November 18<sup>th</sup>, 2021  
Project No.: C228-21

**RE: Wetland Alteration Application – Town Planner Comment Revisions  
52 Goodwin Road, Kittery Point, ME  
Tax Map 58, Lot 51B**

NO.	DESCRIPTION	DATE
B	TOWN PLANNER COMMENT REVISIONS	11/18/21
A	PAPER STREET ABANDONMENT REVISIONS	10/08/21

ROAD PLAN & PROFILE  
GOODWIN ROAD WETLAND ALTERATION  
52 GOODWIN ROAD, KITTERY POINT, MAINE 03905

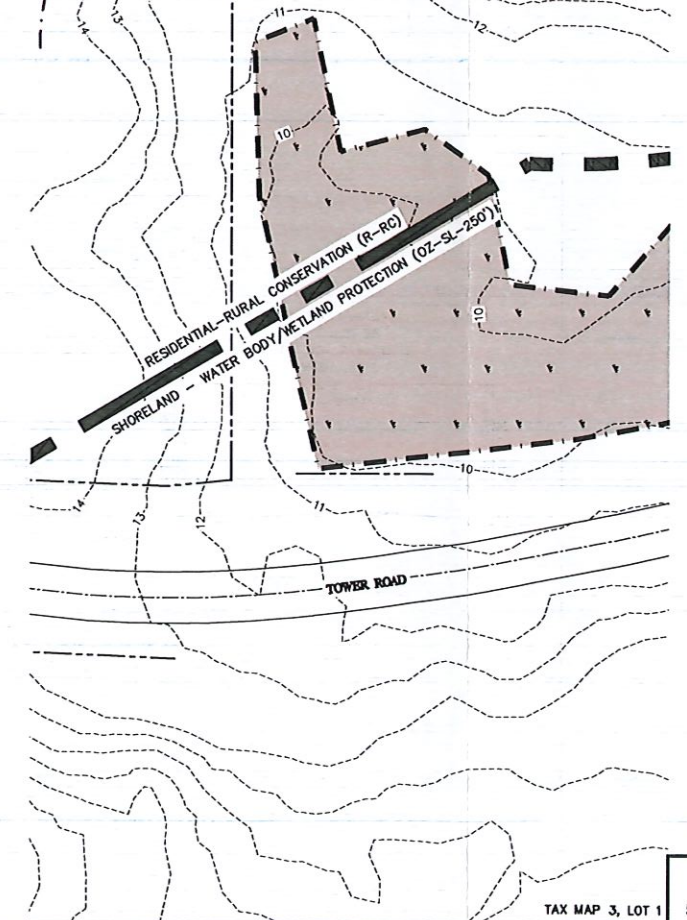
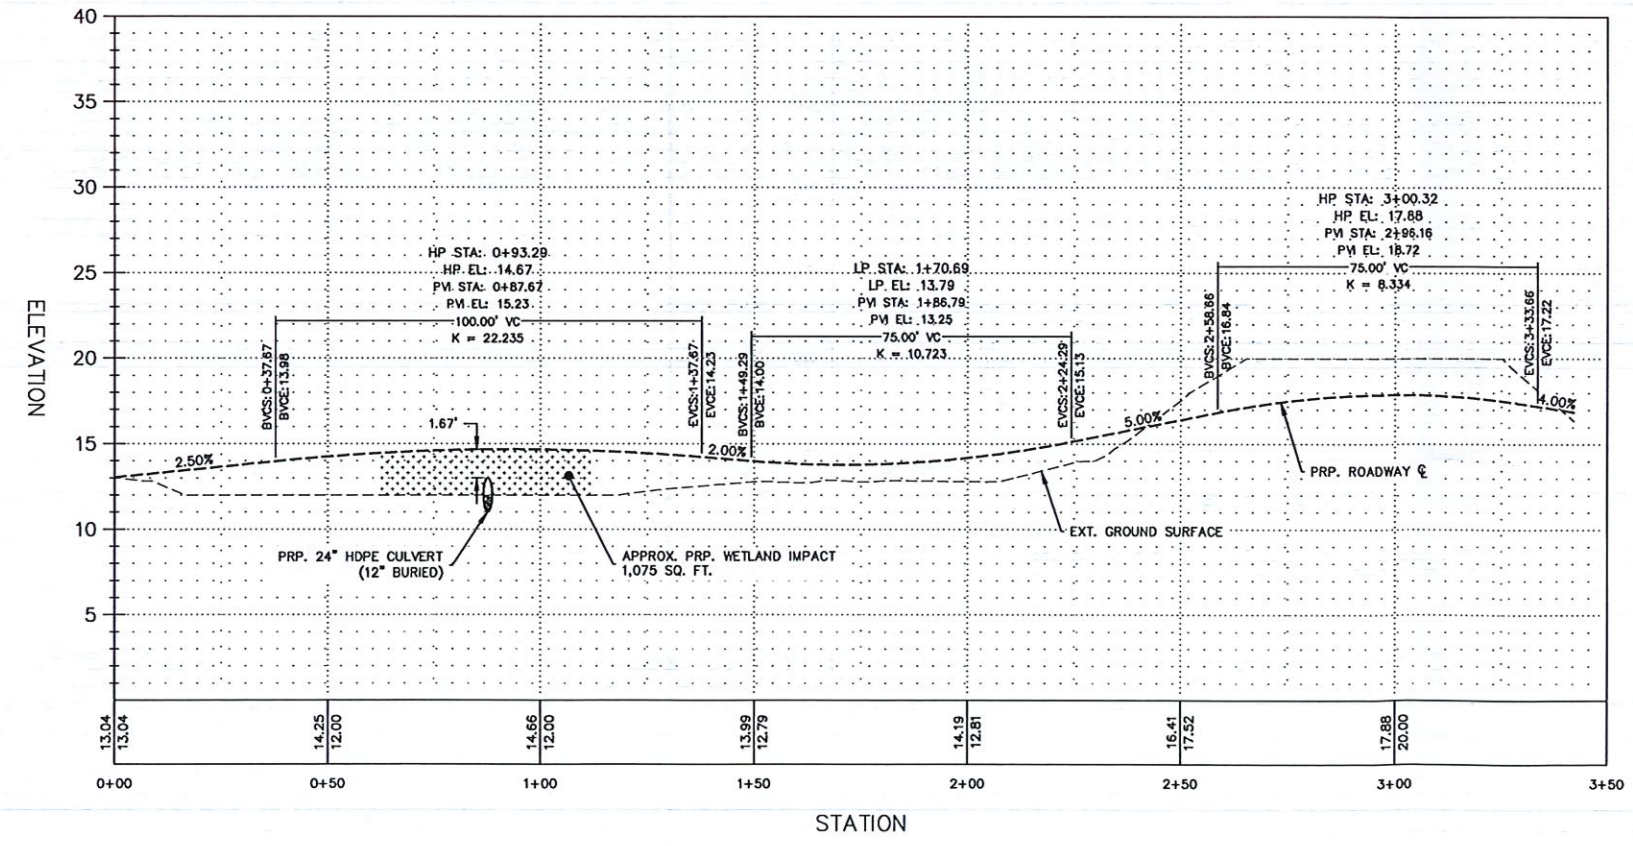
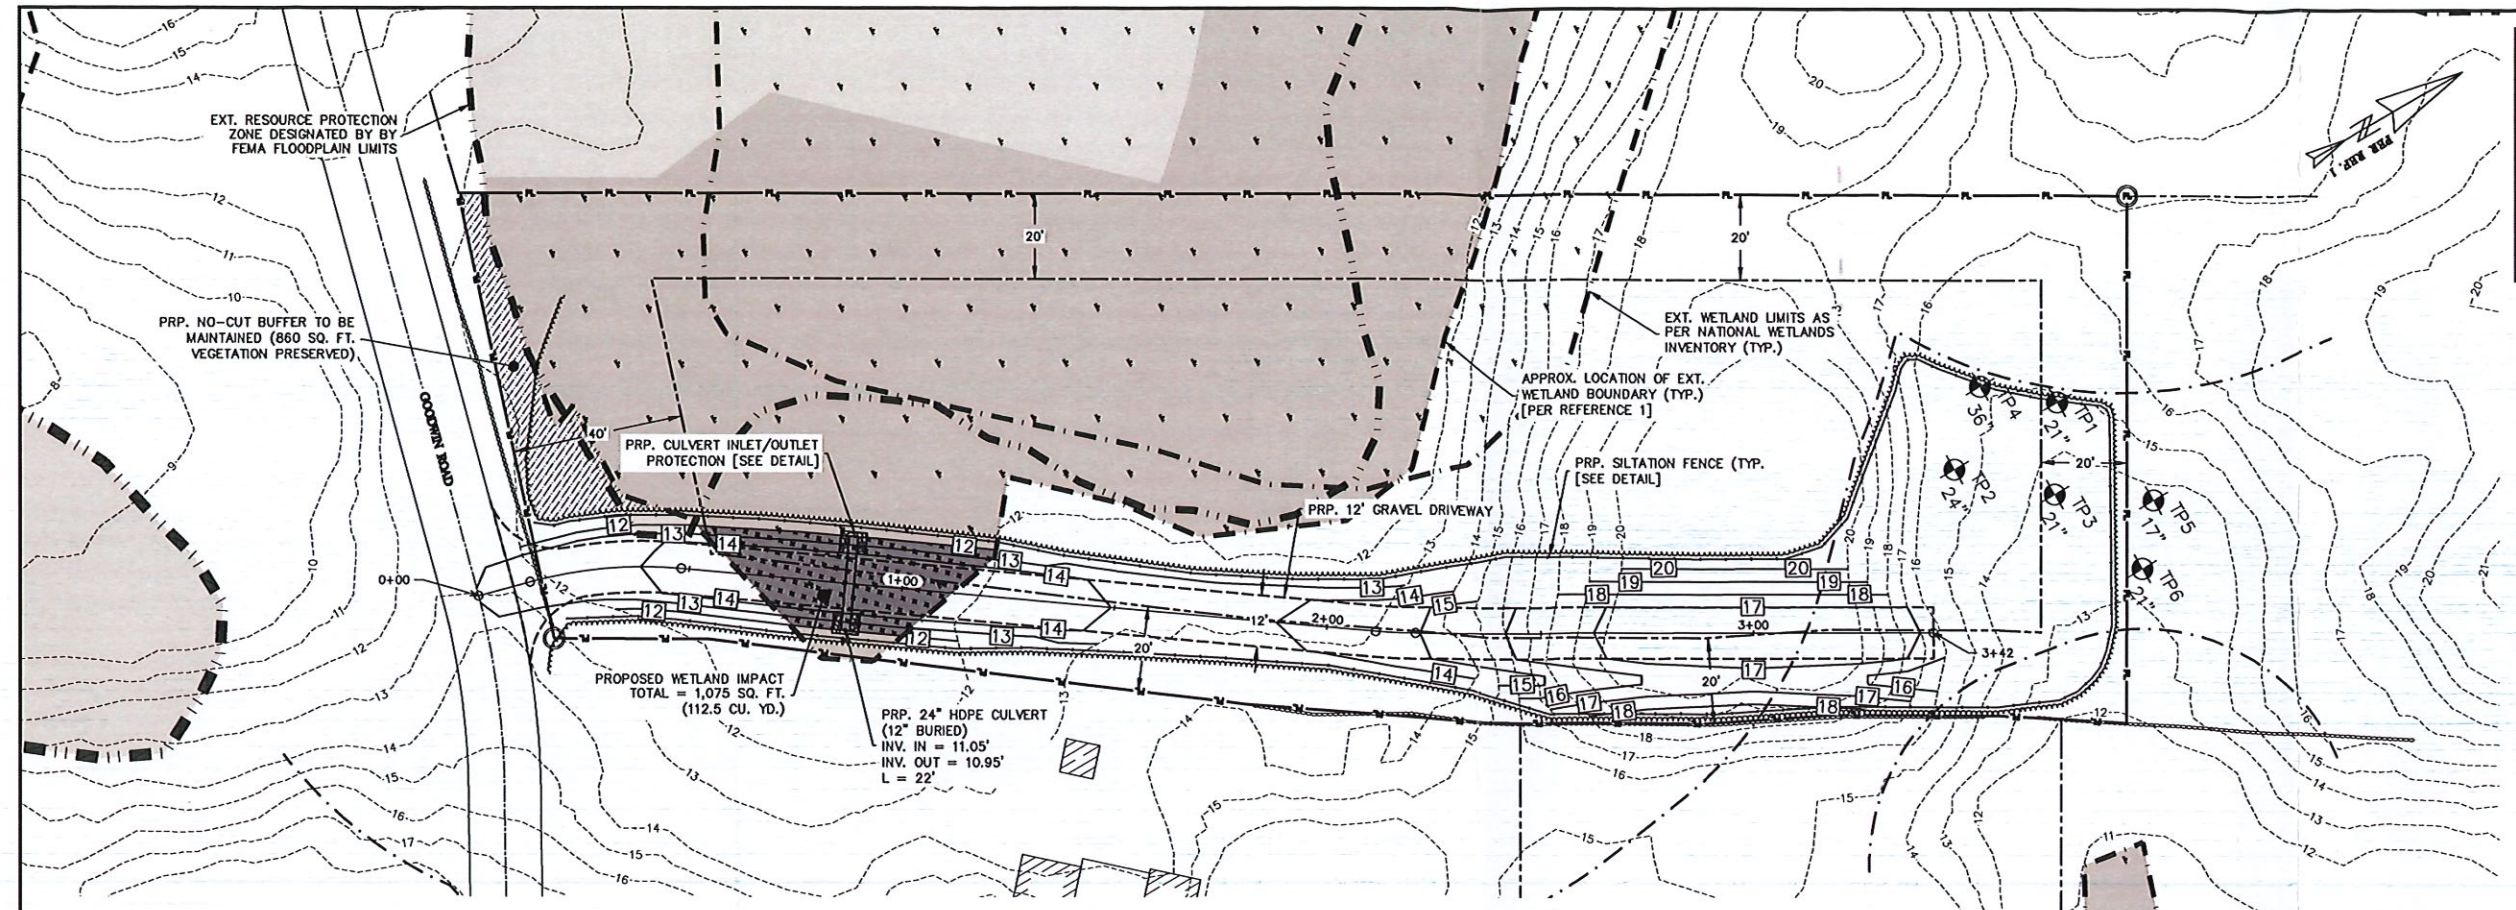
- d. Shoreland Protection Overlay
  - e. Proposed Wetland Impacts
3. General Note #7 on Sheet 2 has been revised to depict the total square footage and cubic yardage of proposed wetland impacts. Callouts to said wetland impact on Sheets 1 & 3 have been revised to also include this information.

DRIVEWAY CROSS-SECTION DETAIL  
(NTS)

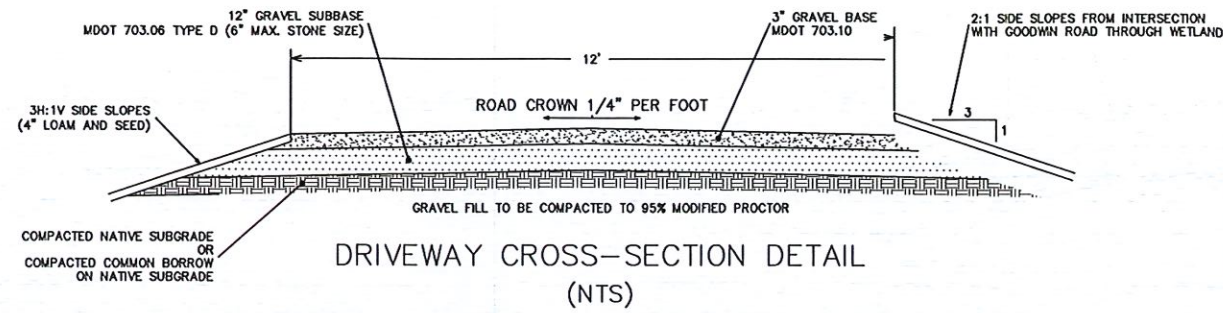
7. An updated draft deed is attached as requested, which references both the wetland mitigation site plan and the no-cut buffer. The plan set has been updated as requested to specify the location of the no-cut buffer and the amount of vegetated area that it shall preserve.
8. General Note #9 on Sheet 2 has been added to document the type, quantity, and origin of the fill required for the proposed development.

9. CULVERT TO BE MAINTAINED FREE AND CLEAR OF DEBRIS WITH A 12" DEEP NATURAL BED BOTTOM.
10. THE TOTAL PROPOSED VOLUME OF FILL REQUIRED FOR THE DEVELOPMENT IS ~300 CU. YD., COMPRISED OF A COMBINATION OF GRAVEL BASE AND GRAVEL SUBBASE SATISFACTORY TO THE STANDARDS DESCRIBED IN THE DRIVEWAY CROSS-SECTION DETAIL ON SHEET 4. FILL SHALL BE SOURCED FROM A LOCAL GRAVEL PIT
